**Final Project-Level Particulate
Matter (PM₁₀) Consultation
Document**

Thornton Road Widening Phase III

**Federal Project No. CSG-0(214)T
ADOT Project No. 0000 PN CSG T0530 01C**

June 9, 2025

Figure 1. Project Location Map

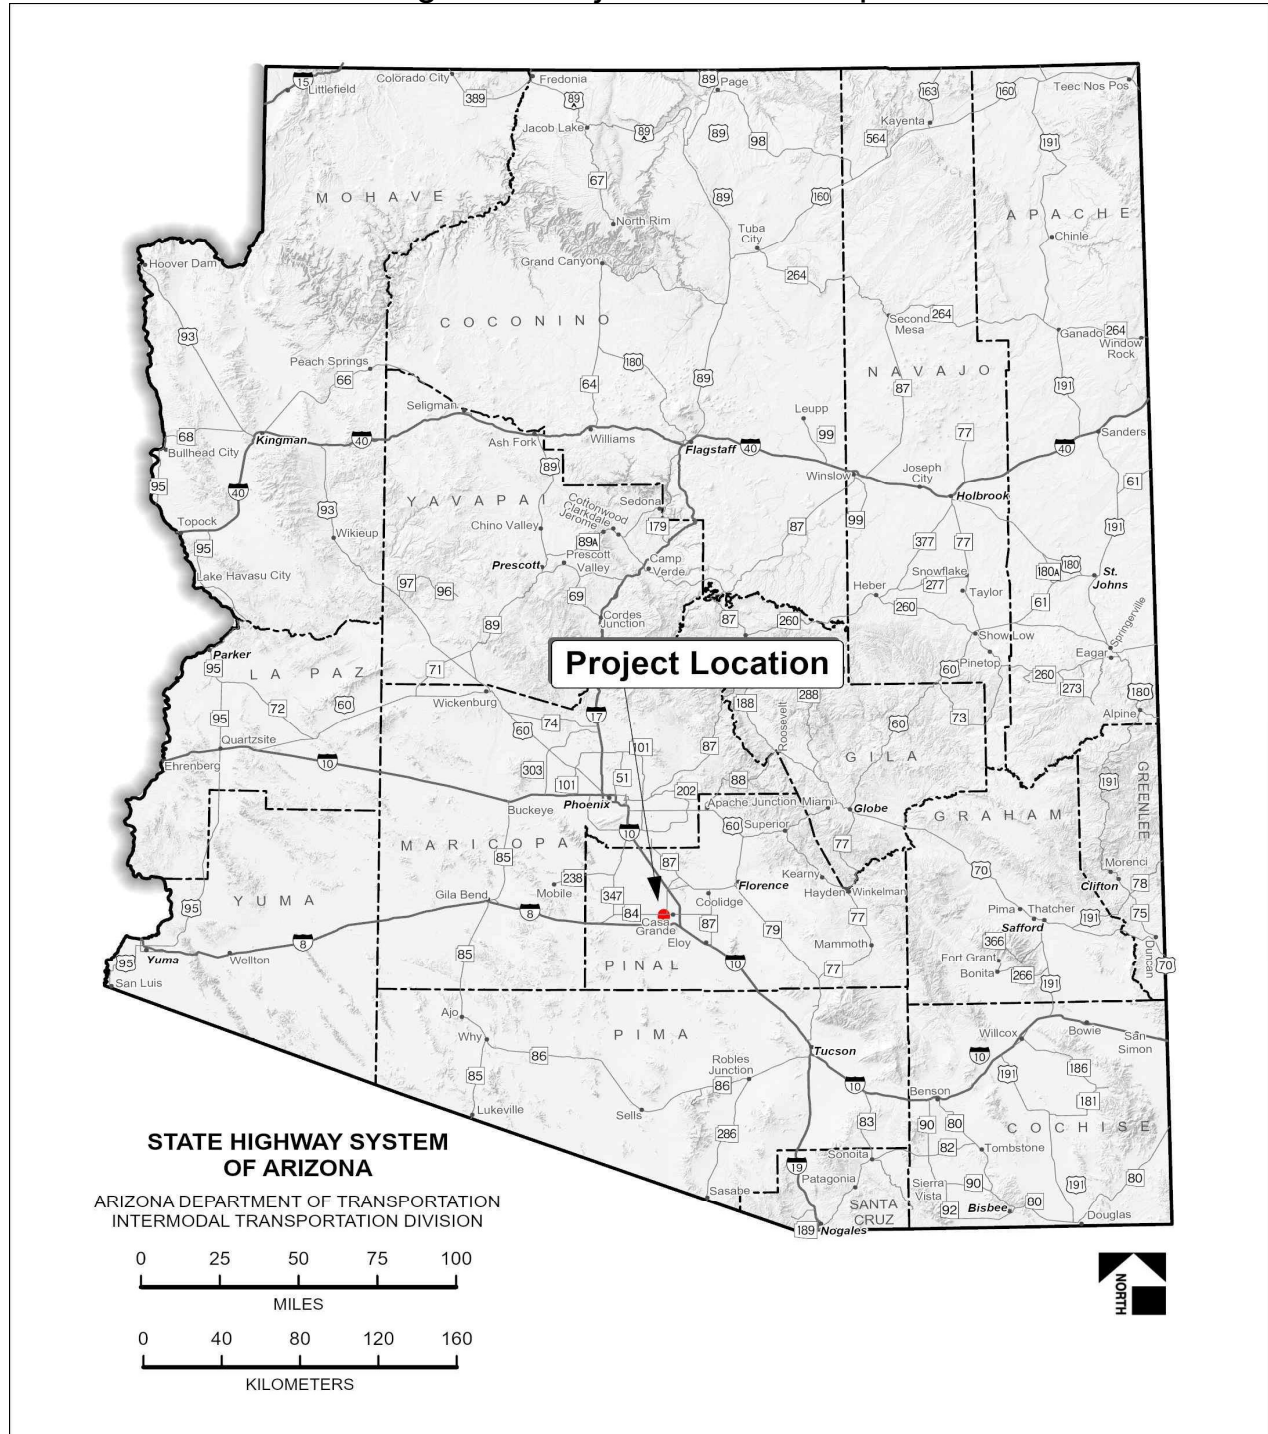
1. Looking at an aerial map of the area, there appears to be quite a few industrial facilities that feed into this section of road, including a distribution center. In this conformity analysis, it is stated that 7% of ADT on this roadway is assumed to be truck traffic, however we would expect this to be more given the amount of industry located around this road. Please explain why this 7% is a conservative assumption for the number of trucks on the road for this project.
2. It is stated that this project will be adding a new Northbound Lane, however there is no difference in ADT from the build and no-build scenario. Why is ADT not projected to change between build and no-build scenarios despite the new lane being added?

1. The horizon year 2050 traffic forecast includes the assumed buildout of Lucid with an employment of roughly 20,000 employees. Concurrently the analysis assumes the Burris Rd corridor will be built out with an overpass of the Union Pacific railroad, tying into SR 387 (Pinal Ave) north of the city airport. The Burris Rd extension is planned as the truck route for this industrial area, as a reliever to Thornton Rd between Peters Rd and Kortsen Rd; and Pinal Ave between Cottonwood Ln and the tie-in of the Burris Rd extension north of the airport. These two factors weighed into the 7% heavy truck factor along this segment of Thornton Rd.

2. The NB roadway capacity of this segment of Thornton Rd between Peters Rd and SR 84 is controlled by the signalized intersection capacity at the SR 84 intersection. This project does not include improvements to the SR 84 intersection. No improvements are envisioned at the SR 84 intersection as the future Burris Rd corridor is envisioned as a significant reliever. Conversely the city wants to see a reduction of vehicular traffic, in particular truck traffic along Thornton, Cottonwood Ln, Kortsen Rd; the Pinal/Cottonwood and Pinal/Kortsen intersections; and Pinal north of Cottonwood as it is causing travel time delays and blocking of access at driveway access to Cottonwood, Kortsen and Pinal near their intersection.
